City of South Bend PLAN COMMISSION

AGENDA

Monday, May 19, 2025 - 4:00 P.M.

Proposed Plat

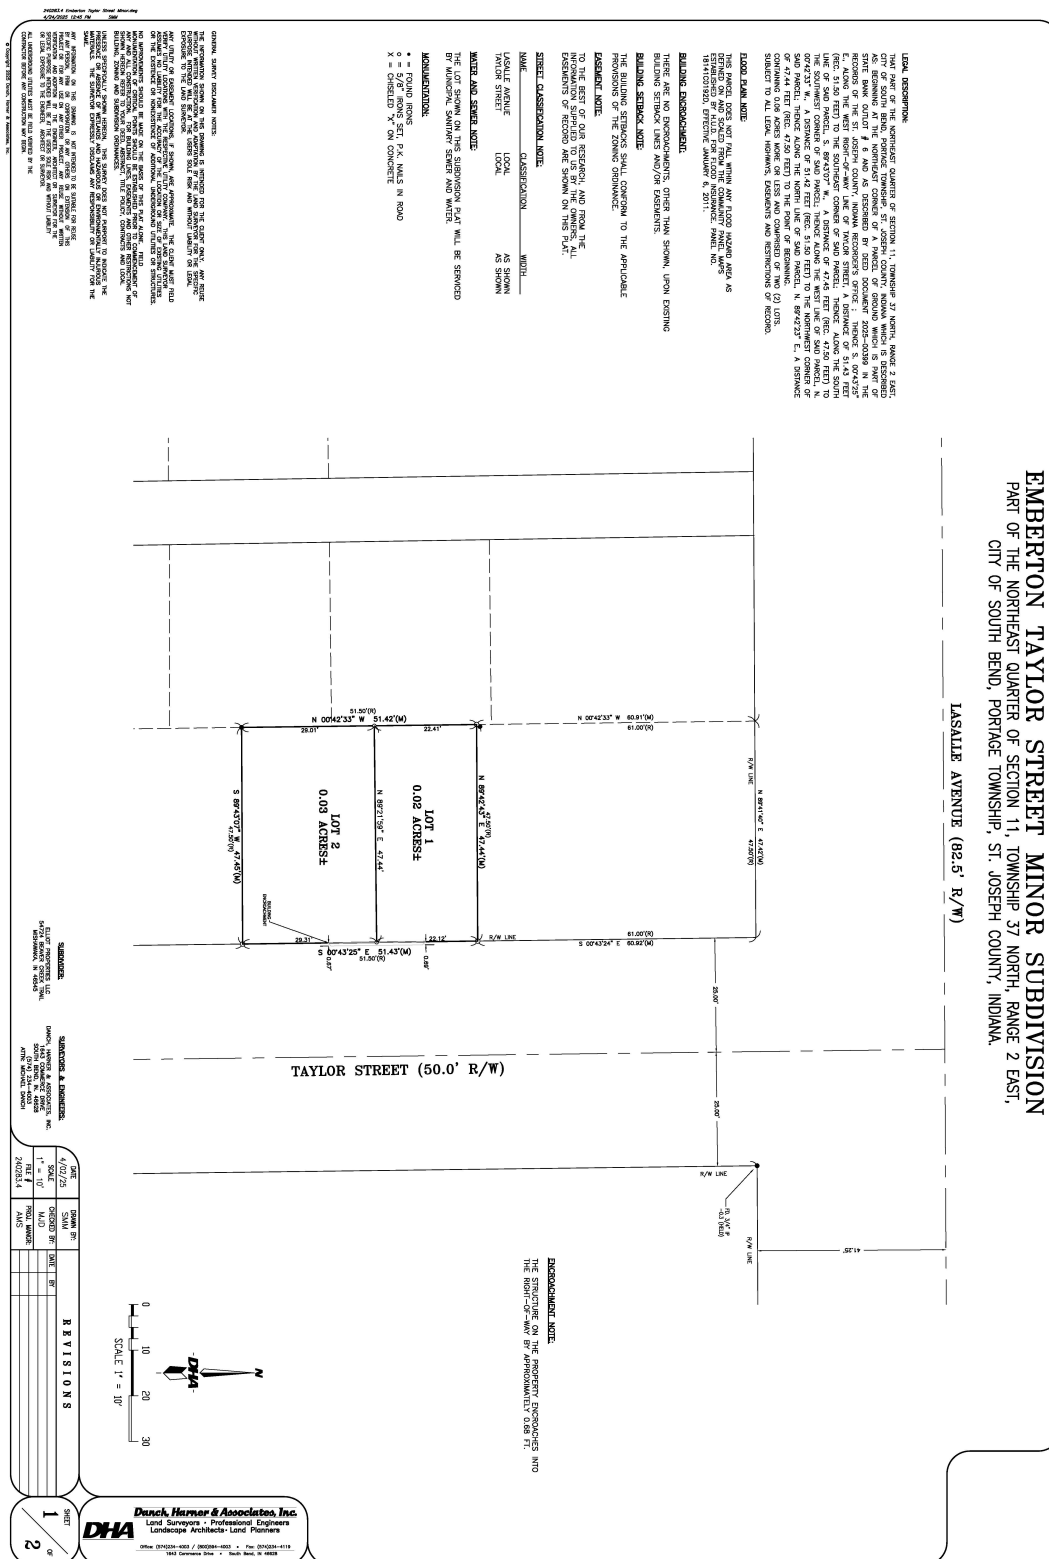
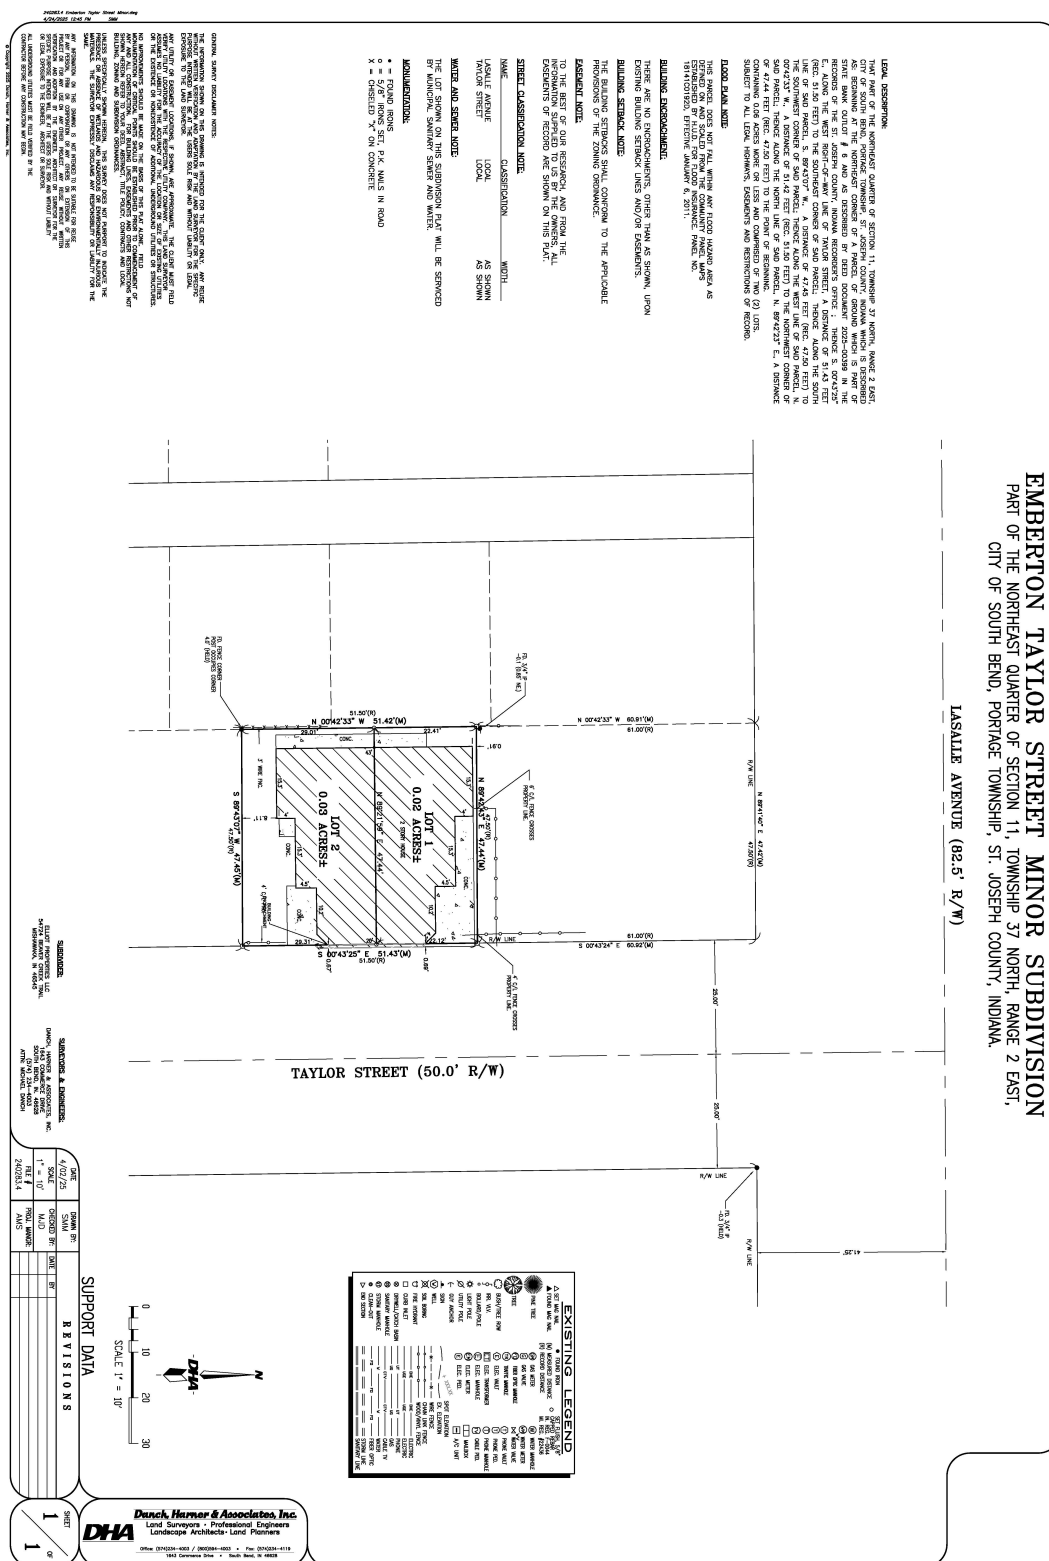
Environmental Data:	A check of the Agency's maps indicates that no environmental hazard areas or wetlands are present.
Drainage:	Not necessary
Rights-Of-Way:	The rights-of-way are correct as shown.
Utilities:	The site will be served by Municipal Water and Municipal Sewer.
Agency Comments:	Each unit will need its own utility connections

Staff Recommendation: The Staff has reviewed this subdivision and finds that if the conditions are met, it complies with the requirements for Primary Approval as specified by the South Bend Subdivision Control Ordinance. The Staff therefore recommends that this subdivision be granted Primary Approval, subject to the following: Each unit having its own utility connection.

Proposed Plat

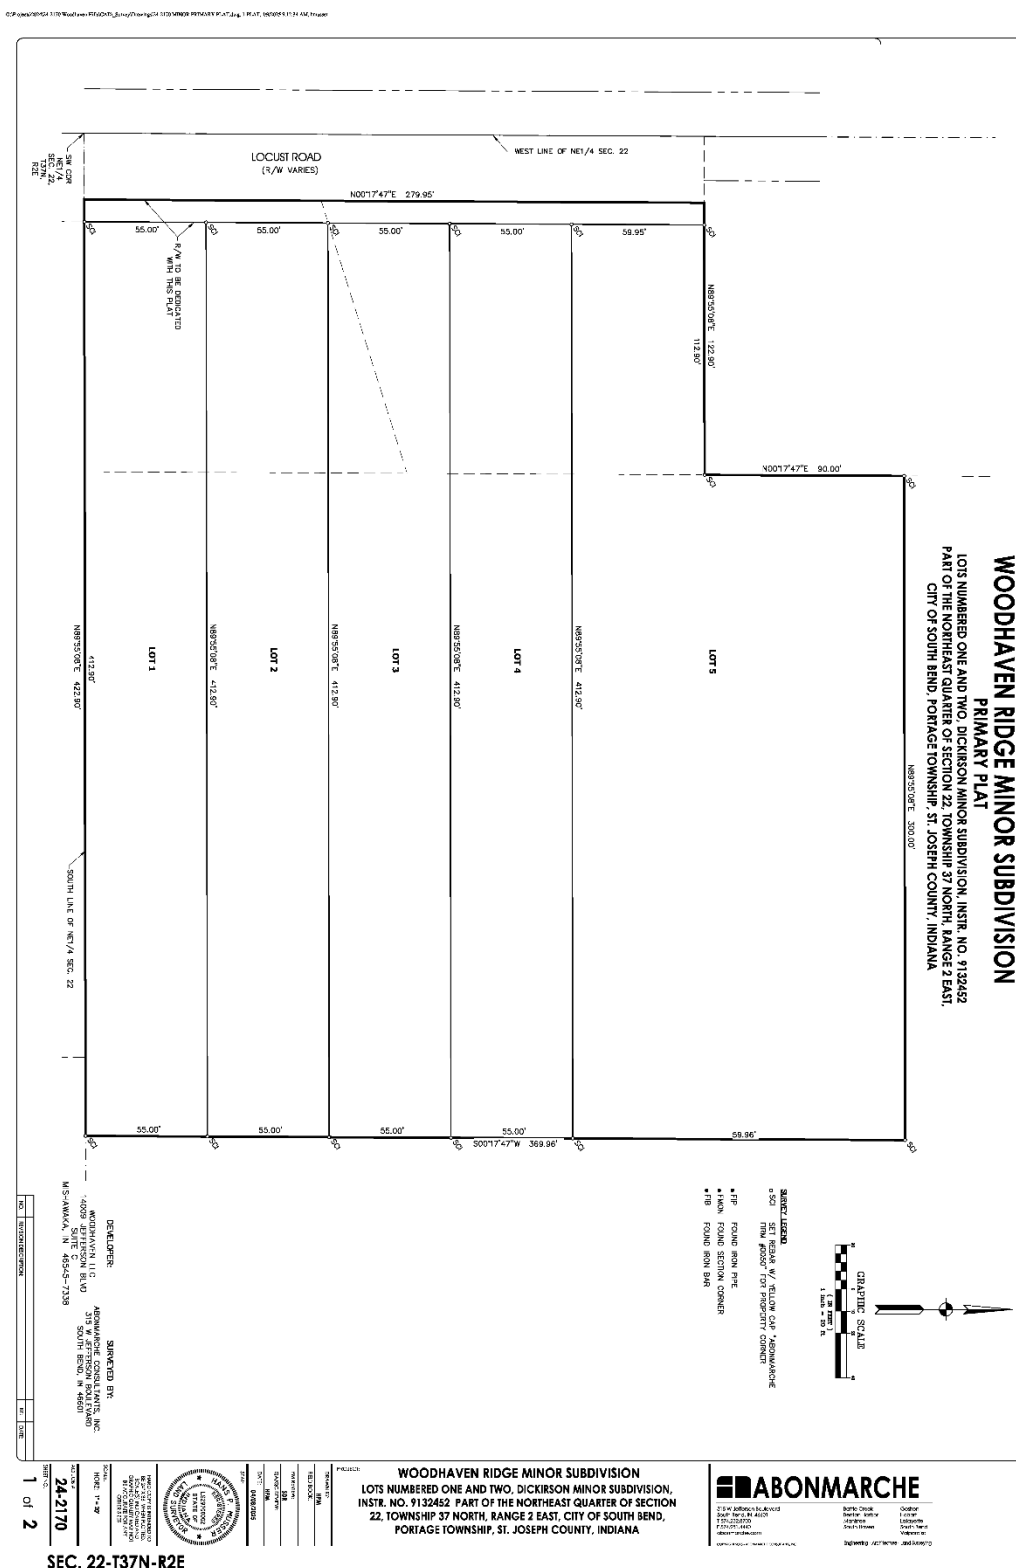
Environmental Data:	A check of the Agency's maps indicates that no environmental hazard areas or wetlands are present.
Drainage:	
Rights-Of-Way:	The rights-of-way are correct as shown.
Utilities:	The site will be served by Municipal Water and Municipal Sewer.
Agency Comments:	Curb and sidewalk will be required once homes are built.

Staff Comments: Provide the instrument number to #7 in General Notes when the boundary survey has been recorded if the secondary has been approved.

Staff Recommendation: The Staff has reviewed this subdivision and finds that if the conditions are met, it complies with the requirements for Primary Approval as specified by the South Bend Subdivision Control Ordinance. The Staff therefore recommends that this subdivision be granted Primary Approval, subject to the following: Providing the instrument number to #7 in General Notes when the boundary survey has been recorded if the secondary has been approved.
